RE: Response to TDE Review – Emergency Vehicle Turning Movements: Intersections and Roadways Around the Proposed Costco Facility
JMT Job No. 20-02057-001

LEFT FROM CROSSGATES MALL ROAD TO MAIN ENTRANCE

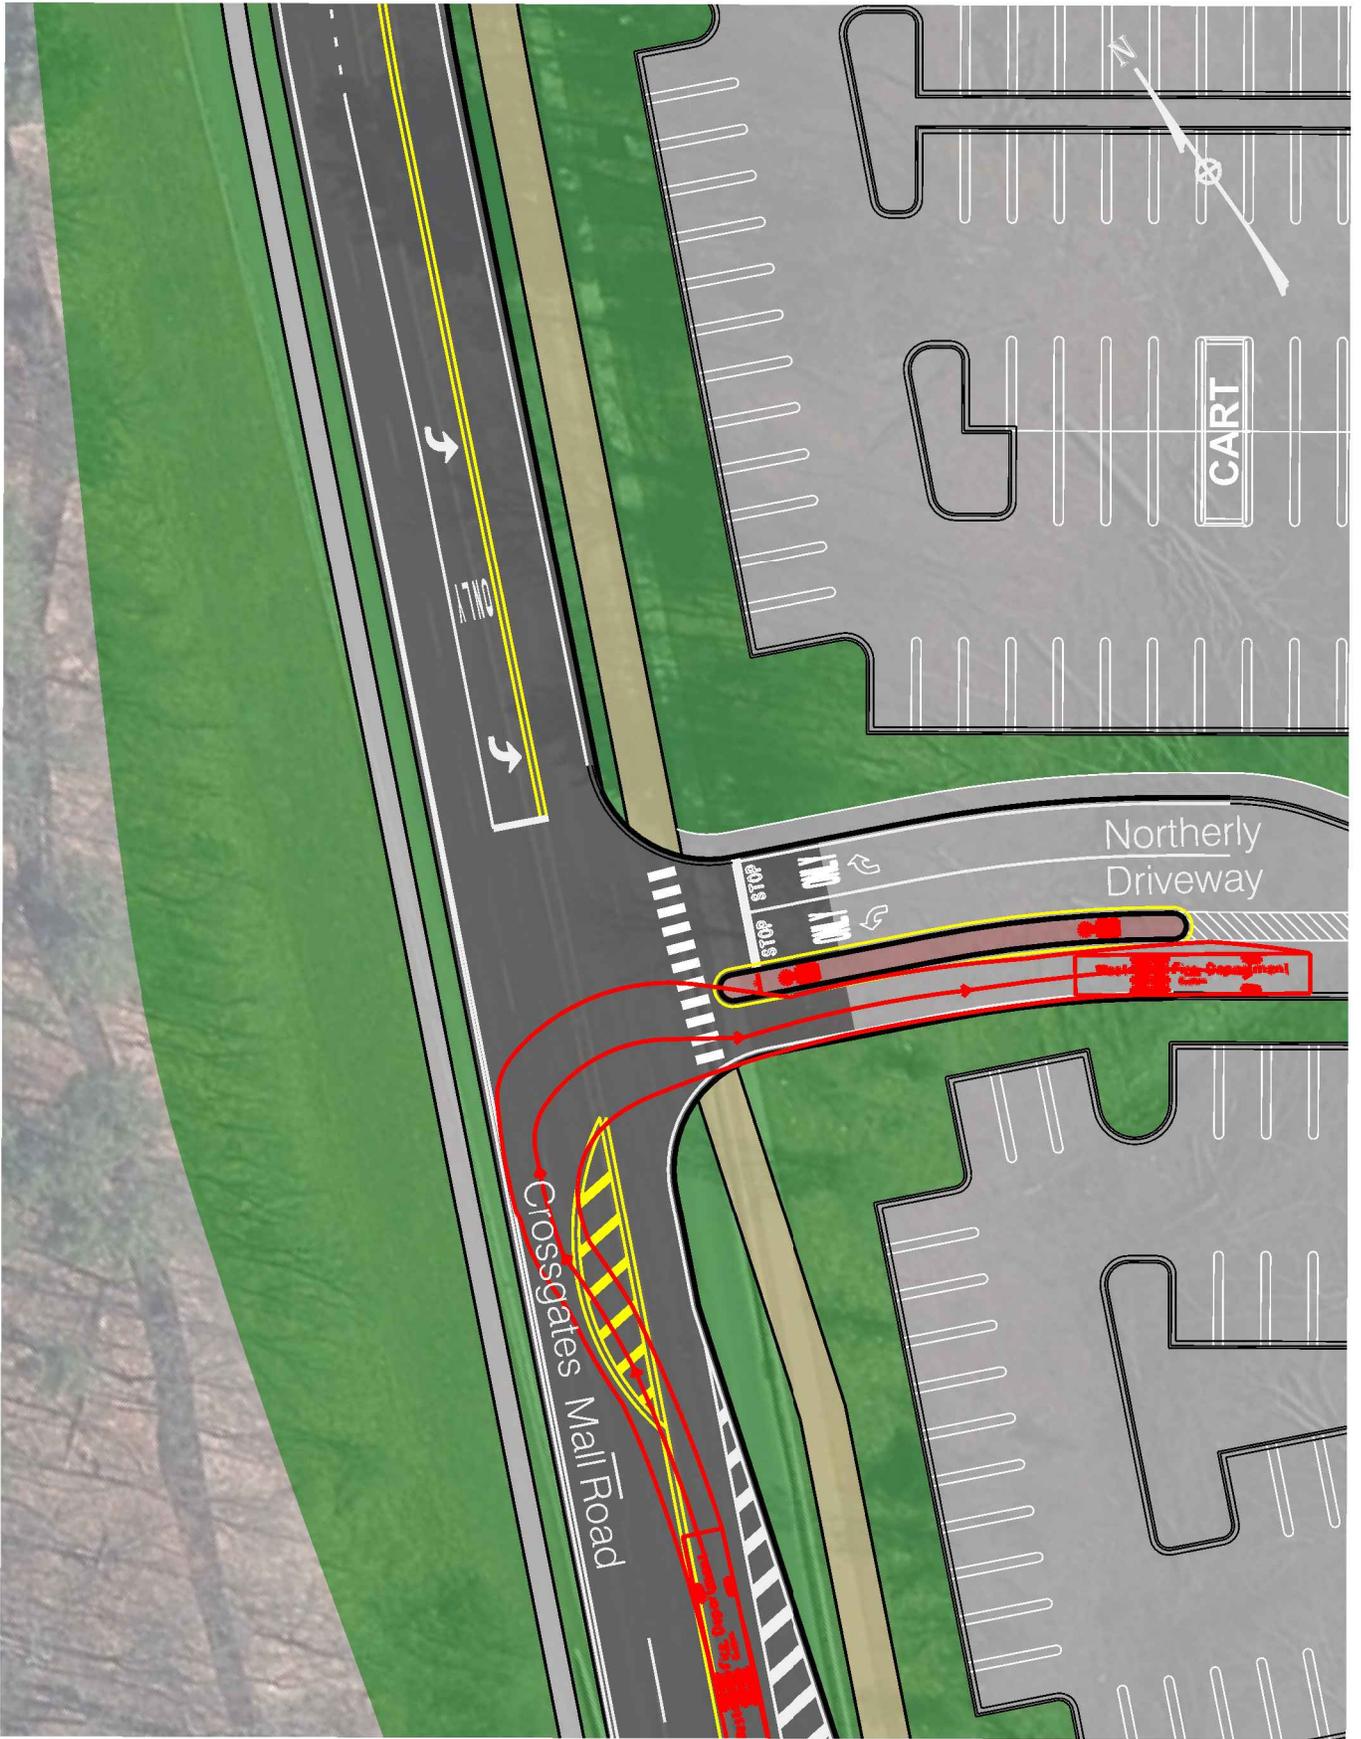
- A. Turning movements for the Westmere Aerial Truck from Crossgates Mall Road into the "main" entrance for emergency vehicles.
 - a. Turning movements have been revised to demonstrate direct access for the Westmere Aerial Truck using the full extents of the paved roadway while avoiding light poles within the median island. See the attached exhibits for updates at this location.

- b. The required extent of mountable curb will be incorporated in final design plans and details.
- D. Turning movements for the Westmere Aerial Truck at the Gabriel Terrace and Western Ave intersection.
